ADDENDUM NO. 2

IRONDALE FIRE STATION No. 3

Project Name: Irondale Fire Station no. 3 **Project No:** CWA Project No. 2023-01

<u></u>	
S	HEET TITLE:
١Ī	evel 1 Plan - Equipmen
Ιō	Connections

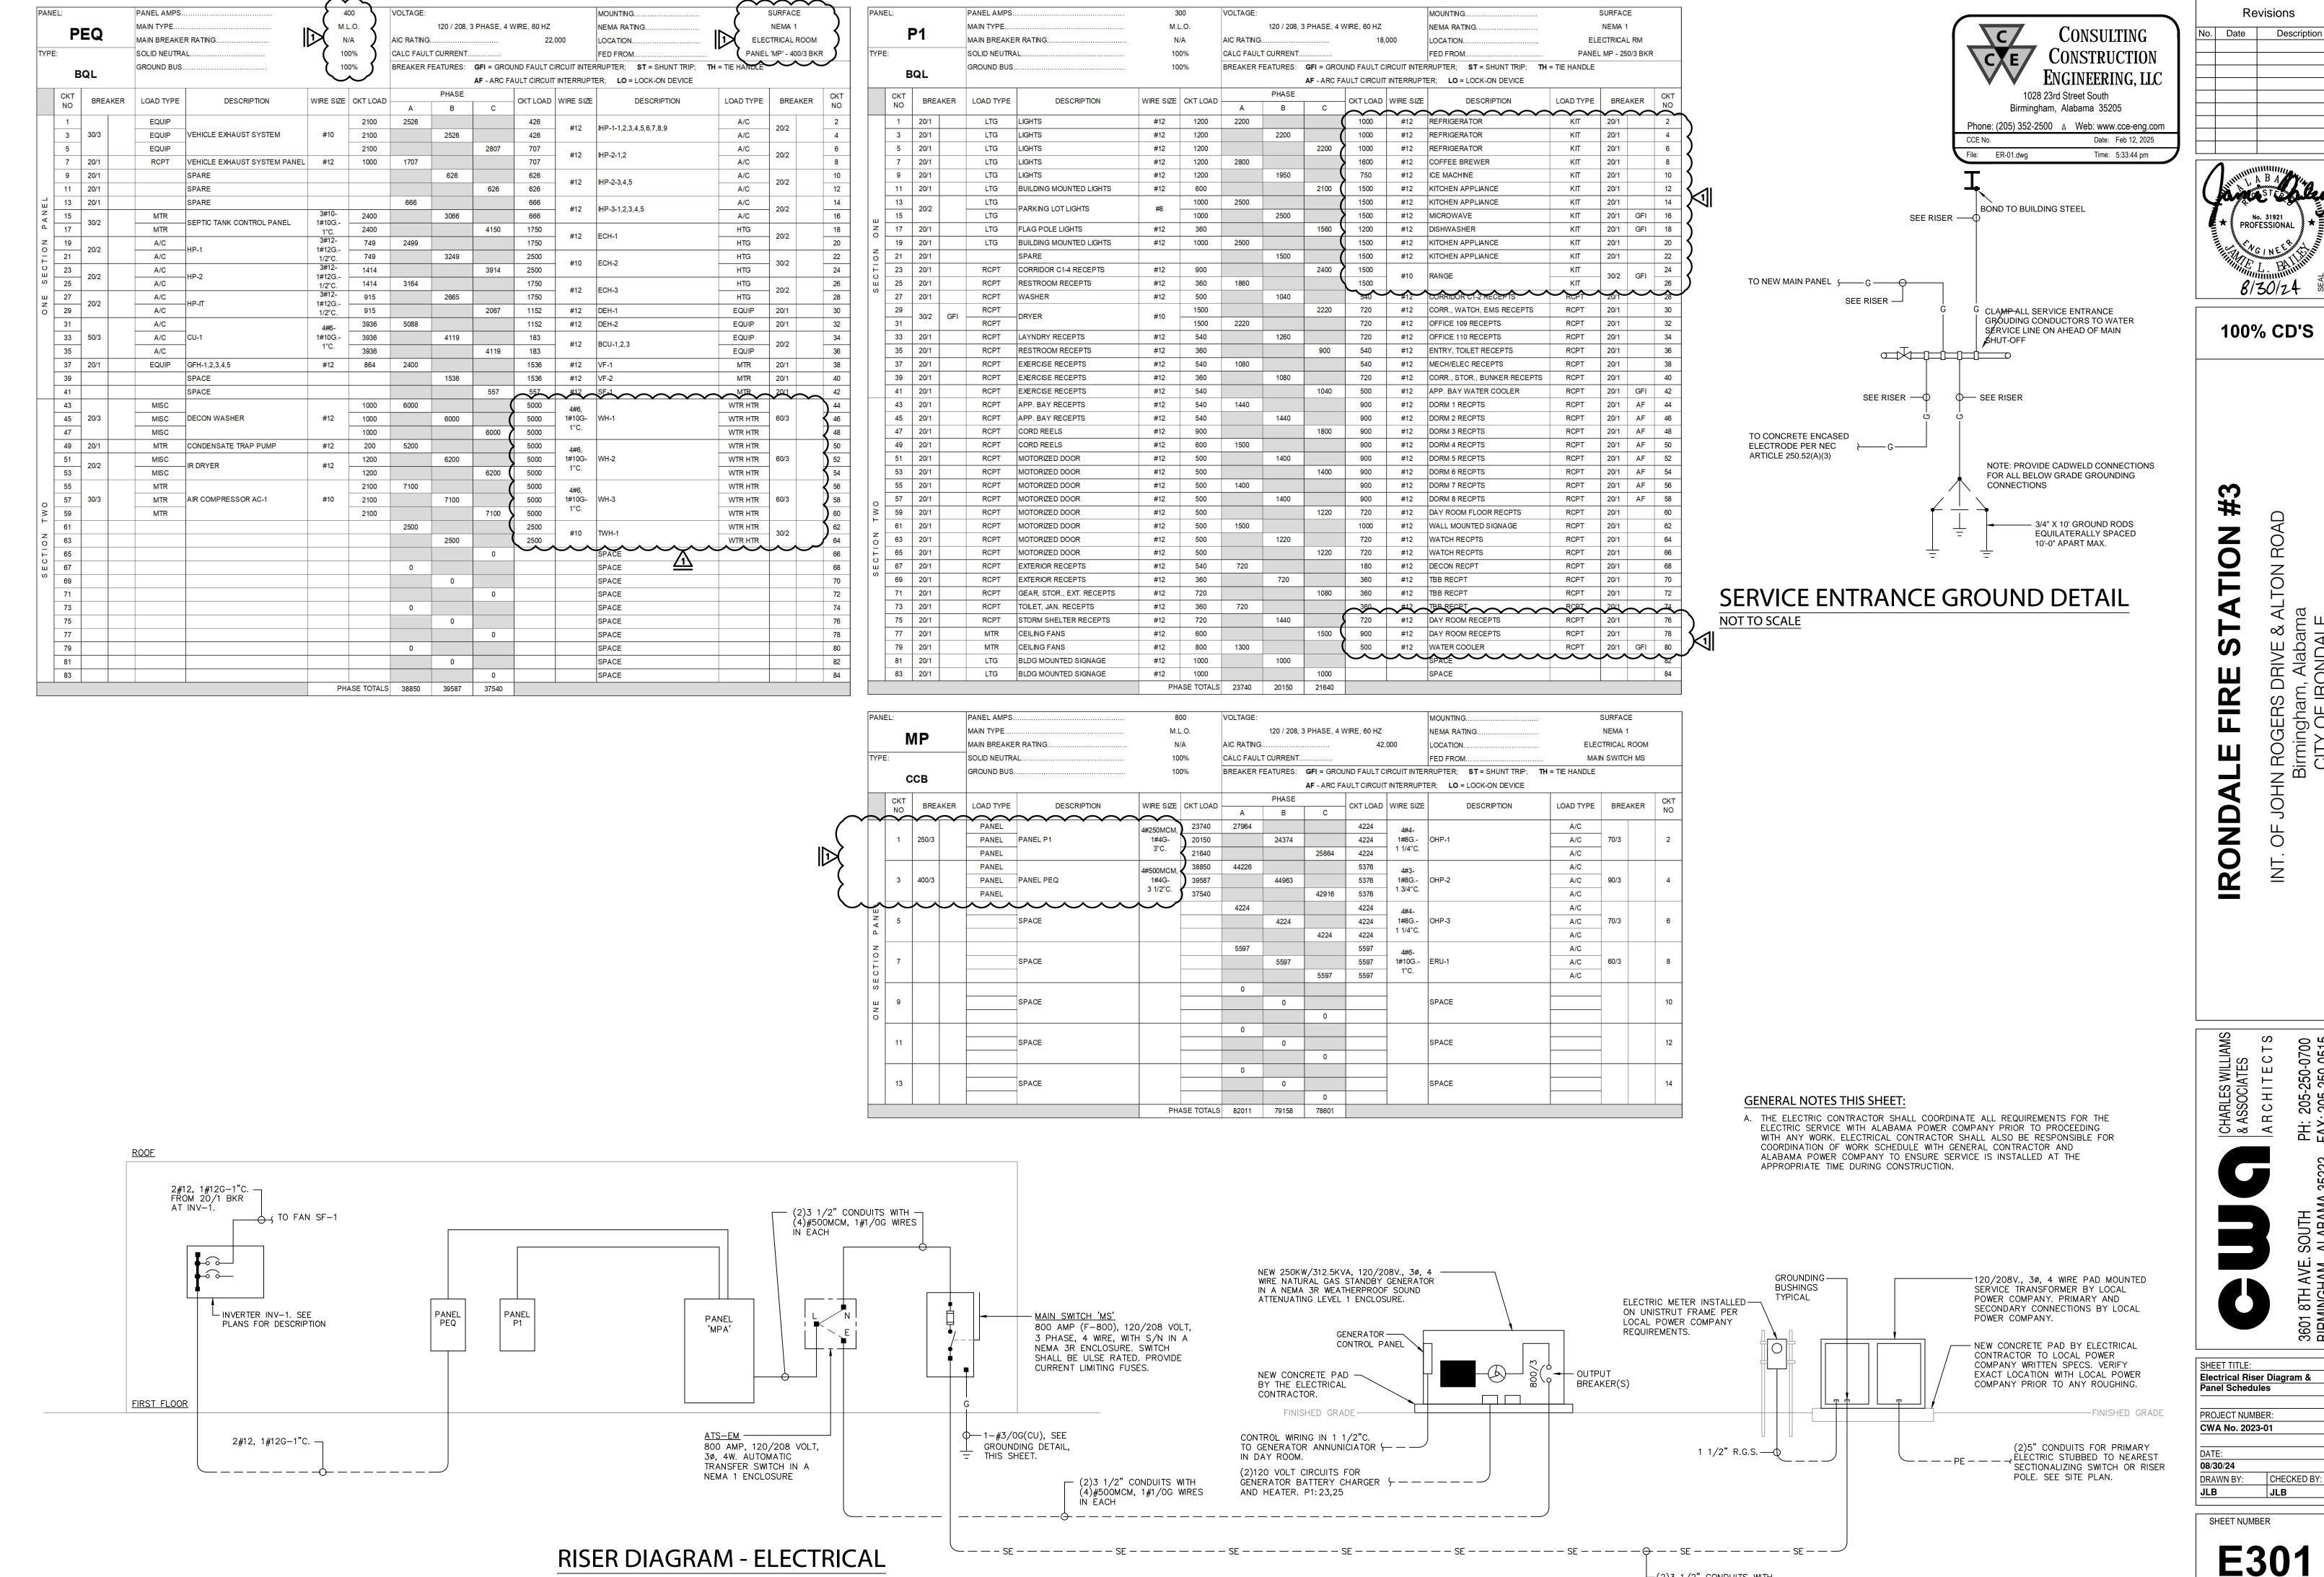
- 18. <u>E204 Level 1 Plan Equipment Connections</u>: Added power requirements for water heating equipment
- 19. <u>E301 Riser Diagram</u>: Updated panel schedules as shown
